Requested Action: Site Plan Approval Extension.

PLANNING COMMISSION STAFF REPORT

STAFF REPORT: Case # 25-3888 6859 Cascade Rd
REPORT DATE: September 15, 2026
PREPARED FOR: Cascade Charter Township Planning Commission
MEETING DATE: October 5, 2026
PREPARED BY: Dan Swallow, Planning Director

APPLICANT: International Beverage, Rishi Makkar
ADDRESS: 6859 Cascade Road
PARCEL NUMBERS: 41-19-09-451-023
REQUESTED ACTION: Site Plan Approval Extension
REQUIREMENTS: Section 14.7 Site Plan Review, E. Effective Date.
EXISTING ZONING: Cascade Village Core (V-VC)
GENERAL LOCATION: The subject parcel is located on the southwest corner of Cascade Rd. SE and Orange Ave. SE.
PARCEL SIZE: 0.62 Acres
EXISTING LAND USE: Commercial – Retail (Liquor Store)
ADJACENT PROPERTIES: N: V-VC, Commercial – Restaurant (Cascade Roadhouse)
E: V-VC, Commercial – Office (Keystone Realty)
S: V-VC, Commercial – Retail (Bridal Elegance)
W: V-VC, Commercial – Restaurant (Jamn Bean Coffee)
• *Wide Right-of-Way: Cascade Rd. and Old 28th Street*

A2.0

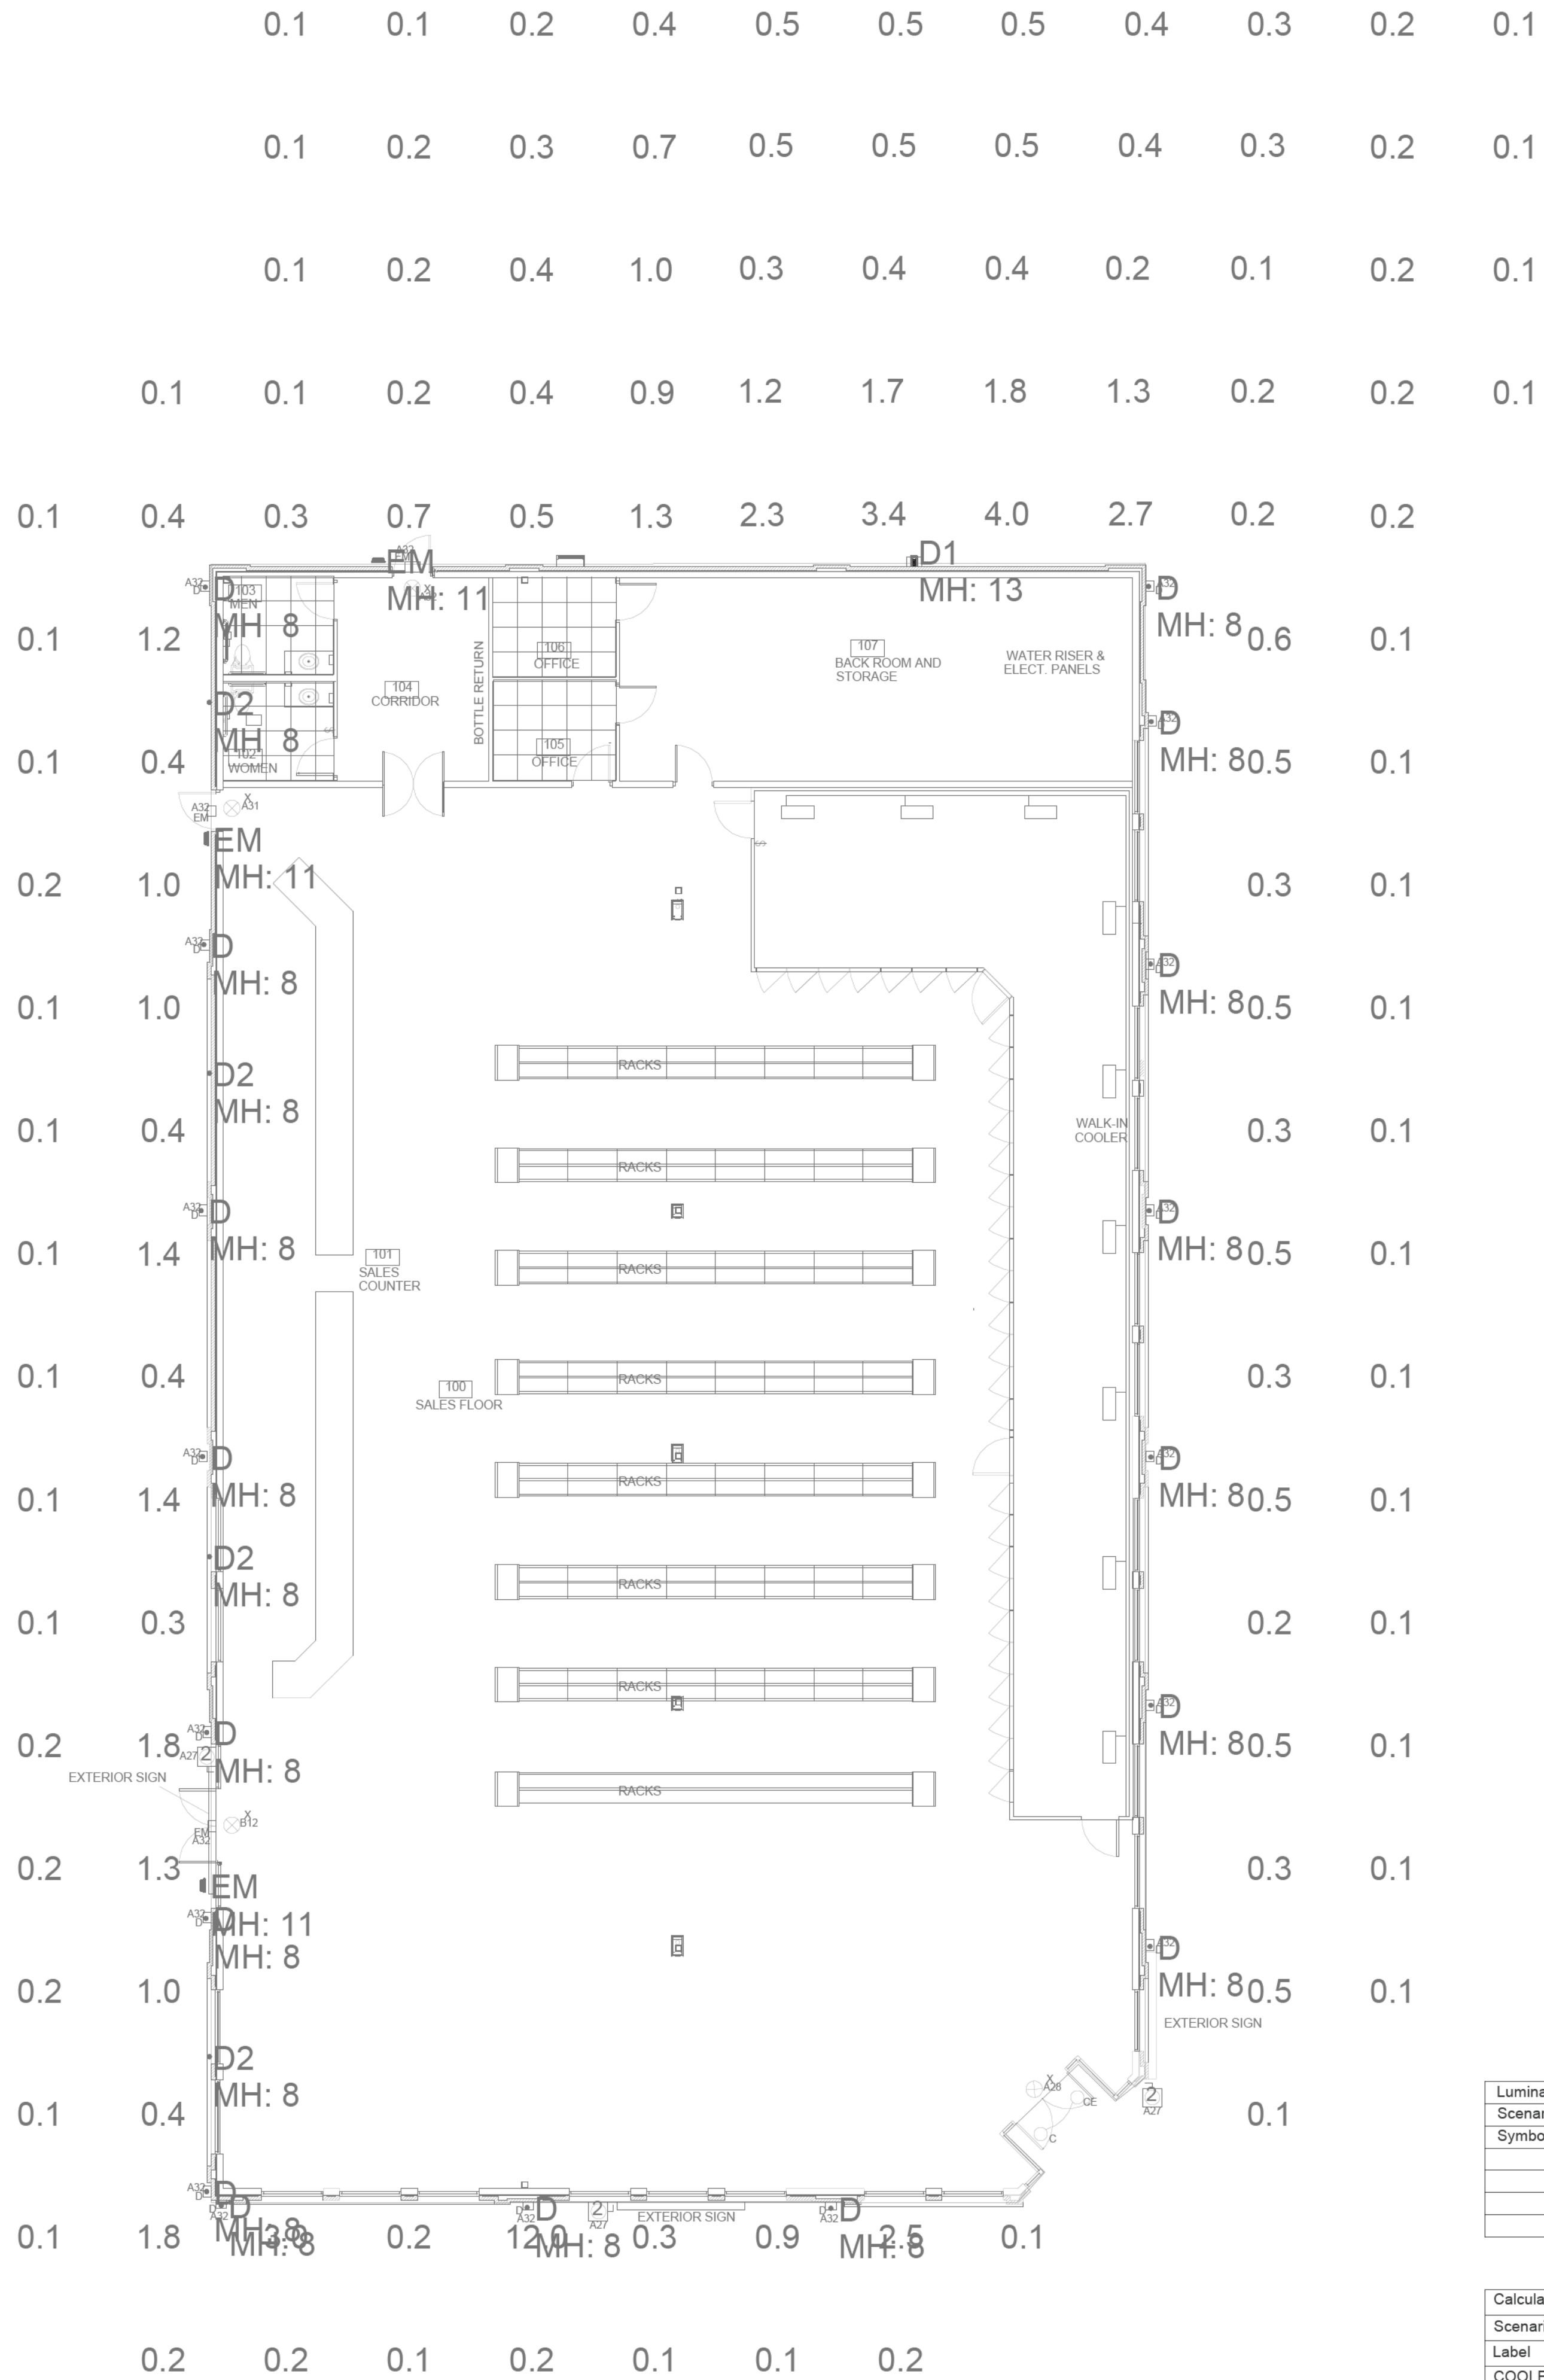
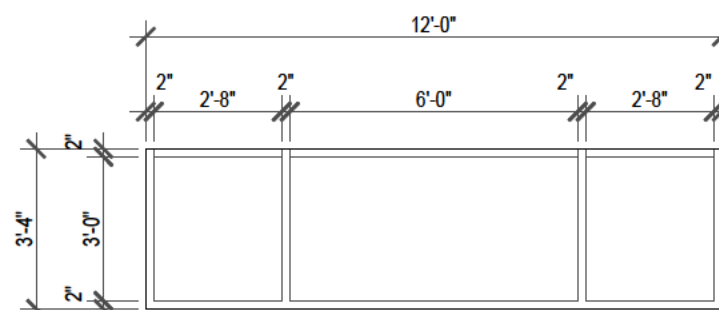
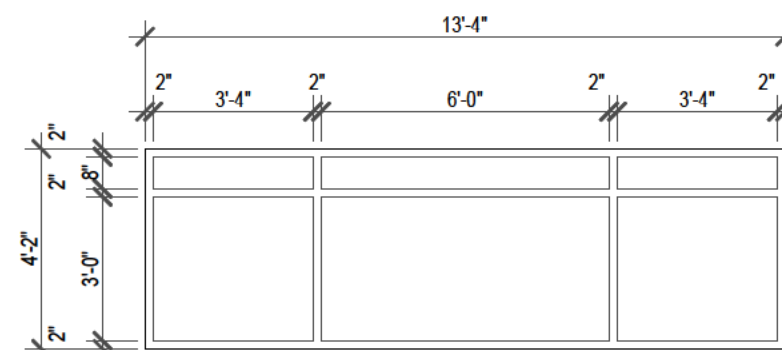
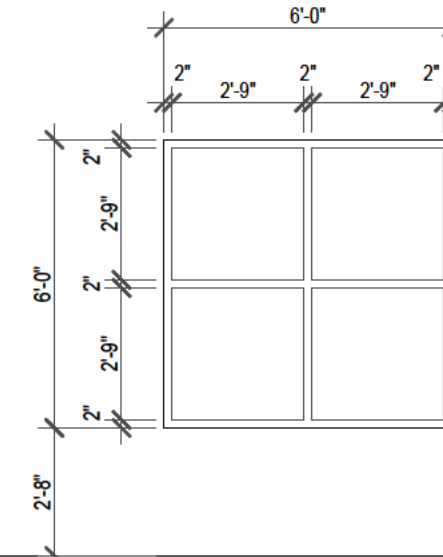
Site Plan Approval Conditions	Progress Made in Interim
1. The VLT (Visible Light Transmission) levels of the	The applicant has revised the elevation drawings and window detail sheets in the

windows be approved by the Planning Department in advance of a building permit.	site plan package to stipulate a “ Clear ” glazing to be installed in the required window openings (Seet Attached Plan Sheets A2.0 and A5.0 from Speed Architects)

ALUM. STOREFRONT SYSTEM W/
 1" LOW E, CLEAR INSULATED
 GLAZING (MIN. 80% VTL)

ALUM. STOREFRONT SYSTEM W/
1" LOW E, TINTED, INSULATED
SPANDREL GLAZING SYSTEM
(SPECIFIED TINT MAY NOT MEET
MIN. 80% VLT REQUIREMENT)
